**Date: 8/1/2025
CAL FTL 54-038**

Subject: Wiring Support Bracket Reroute

Model: 5th Generation Cascadia

Build Date Range: Selected Vehicles Built Between June 2, 2025, and July 1, 2025

Fig. 1 Wiring Support Bracket Rerouting

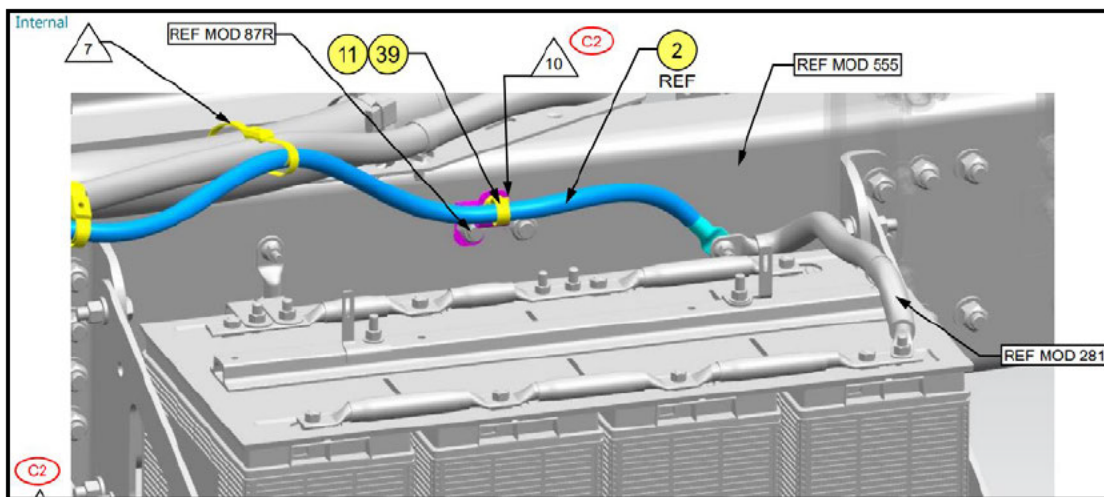
Your vehicle may have a bracket that is positioned downward. This procedure will help you position the bracket upward to ensure the proper wiring routing on the unit.

1. Park the vehicle on a level surface, shut down the engine, and apply the parking brakes. Chock the tires.
2. Disconnect the negative battery cables from the batteries.
3. Locate the bracket on the frame rails near the positive auxiliary cables.
4. Position the bracket upward (a 180-degree rotation) using a diagram D66-22650-001 as reference and complete the installation according to the R&C guidelines. See Fig. 1.
